The Network Building  
Level 08 Plant Area – Generator Flue positioning  
ESG/SKE/010823

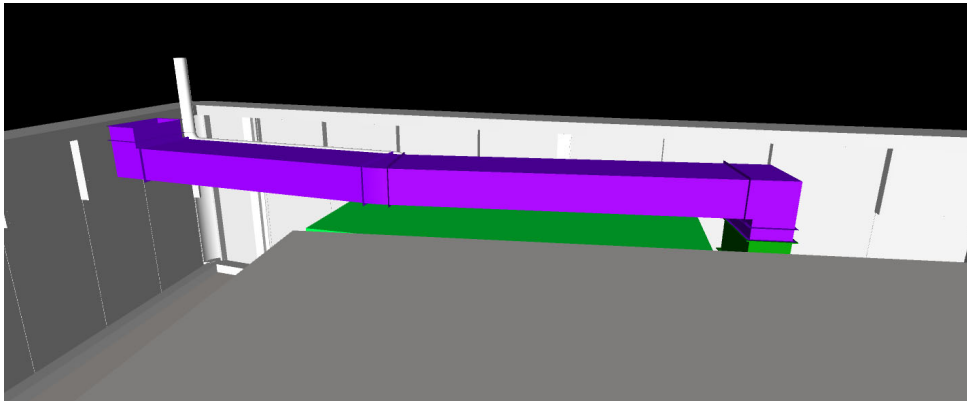
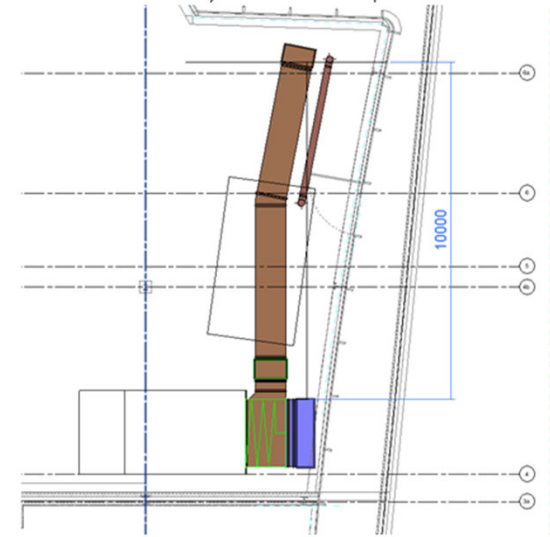
- Generator Flue to terminate 1m above Plantscreen/parapet
- AHU RF.01-WC-East exhaust ductwork relocated – now alongside generator flue
- AHU RF.01-WC-East intake ductwork relocated to maintain 10m separation from exhaust positions
- Suitable cowl/mesh detail shall be provided to intake/exhaust openings during detailed design
